# NMA - PL6

## Flitcroft House

## 1.1 Introduction to Revisions

In accordance with the approved scheme (2022/3335/P), granted on 11.10.2023, DMBA, in collaboration with E&A Property Investment Company Ltd., is seeking approval for a series of minor amendments to the development.

## 3.5 Massing Comparisons from Street View

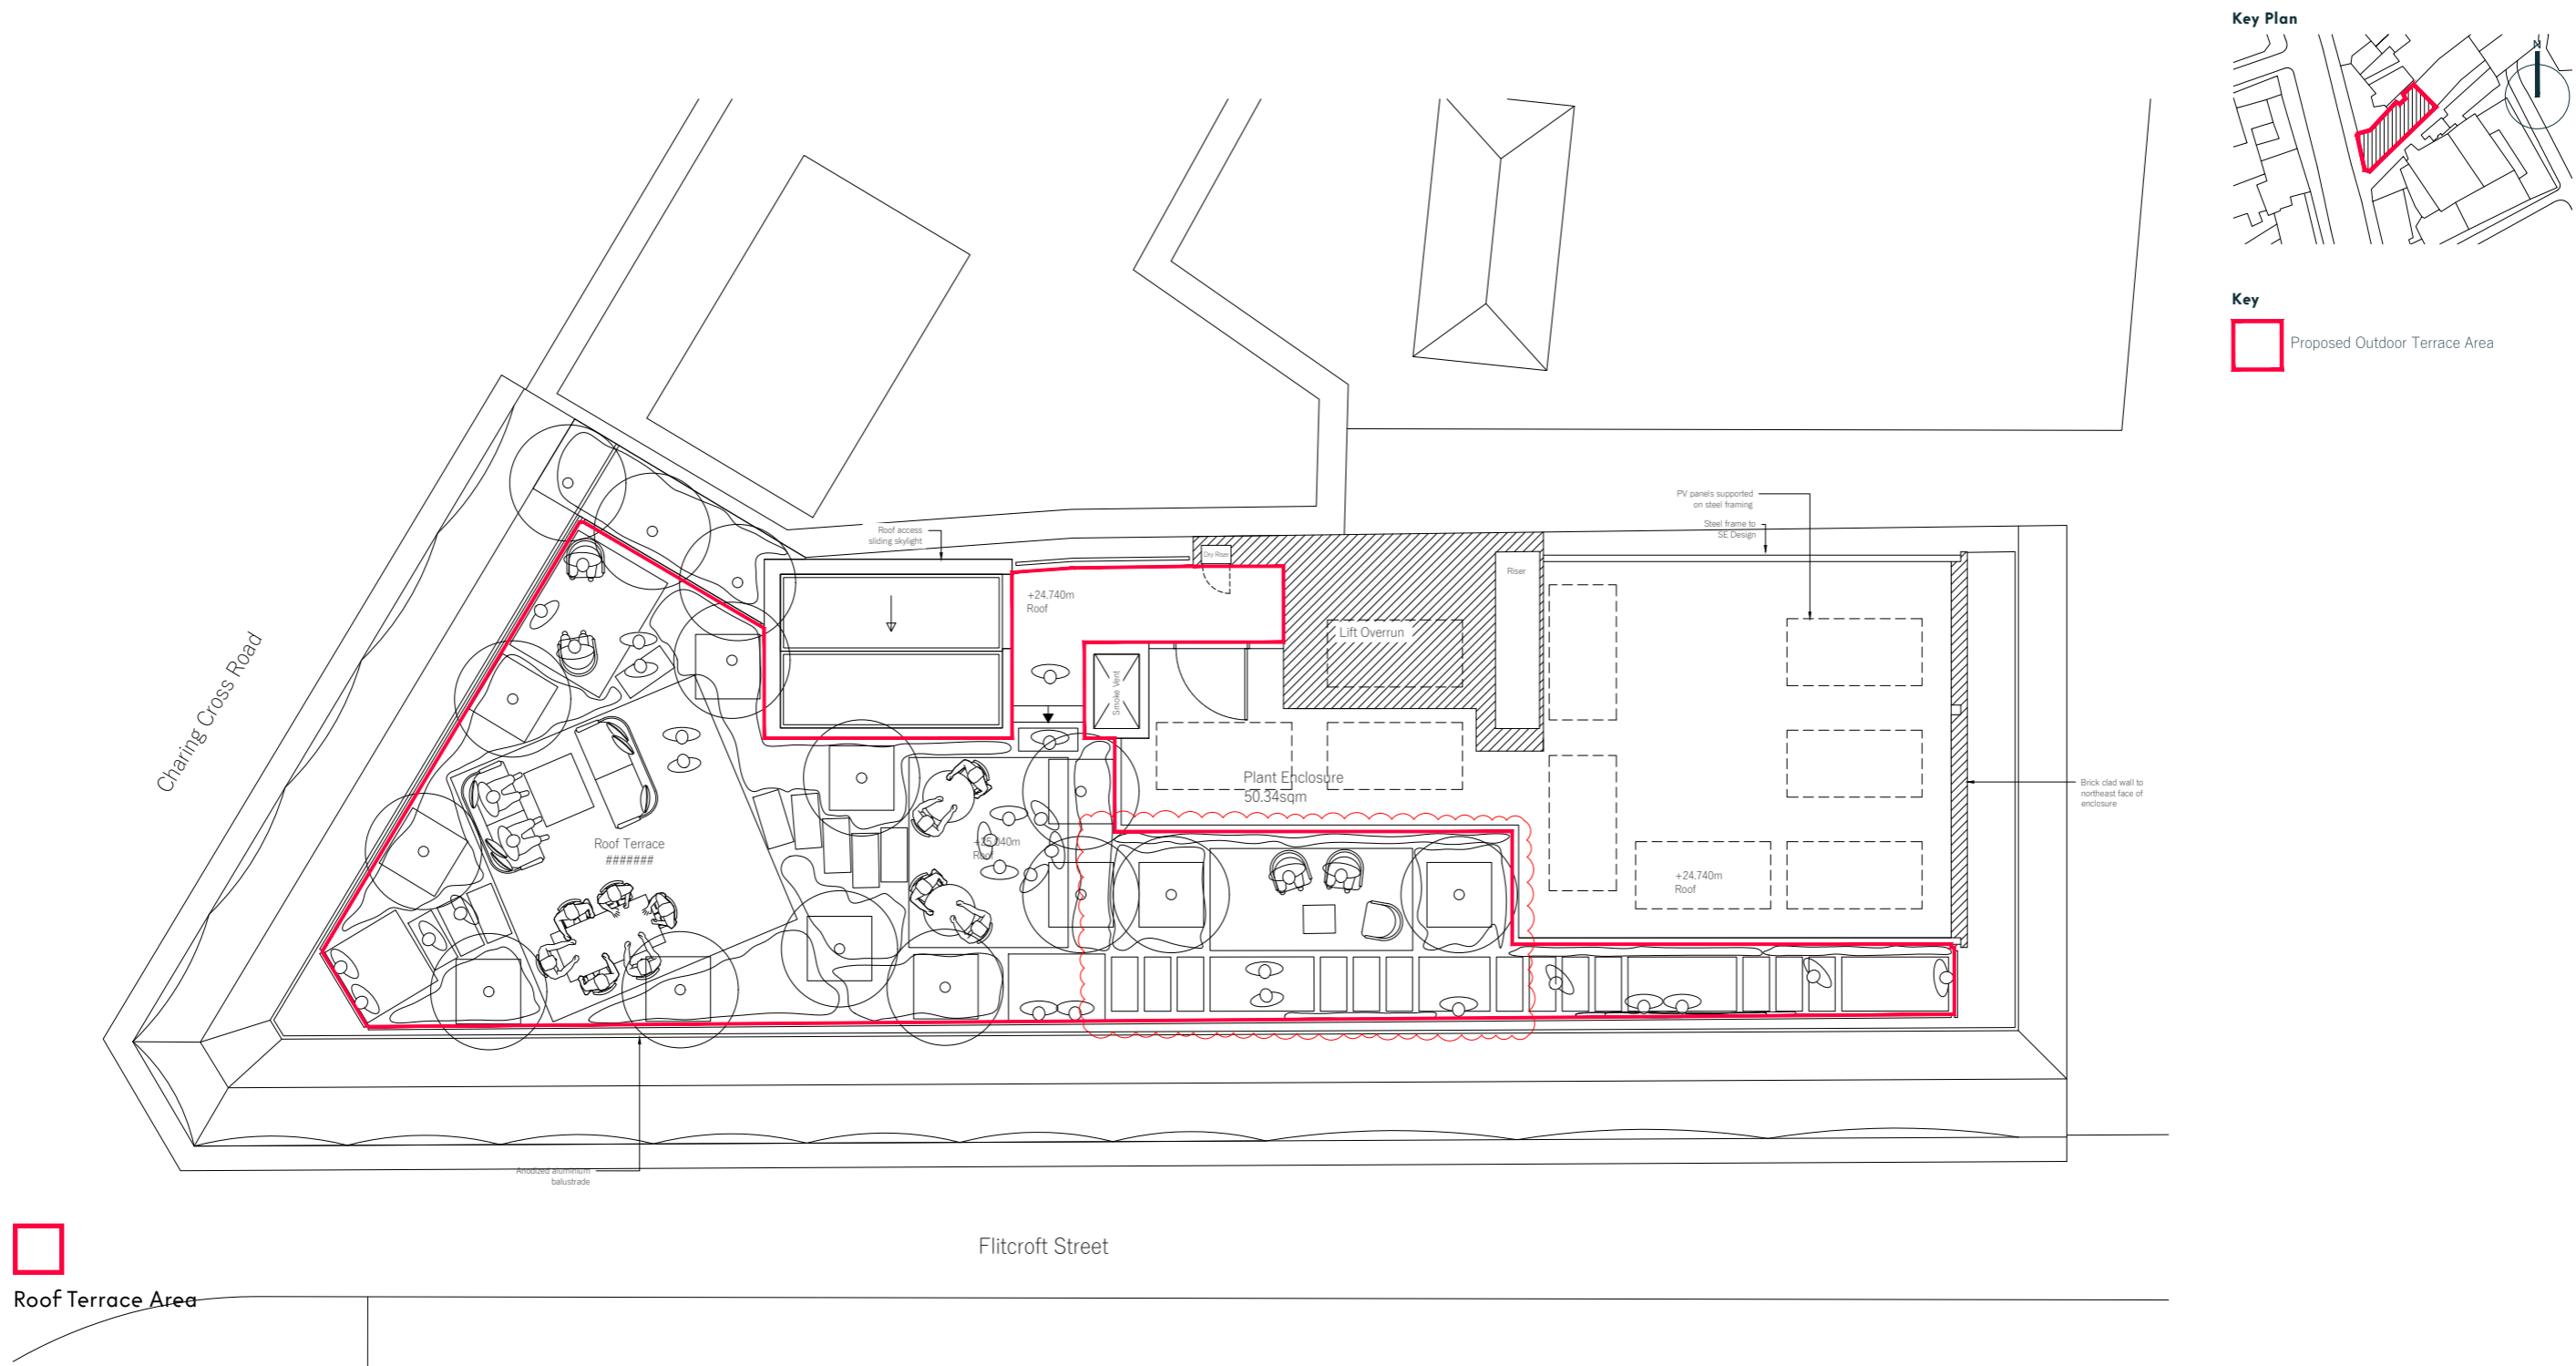
Impact of Fire Engineer's Commentary - Before Further Design Development

Impact of Fire Engineer's Commentary - After Design Development
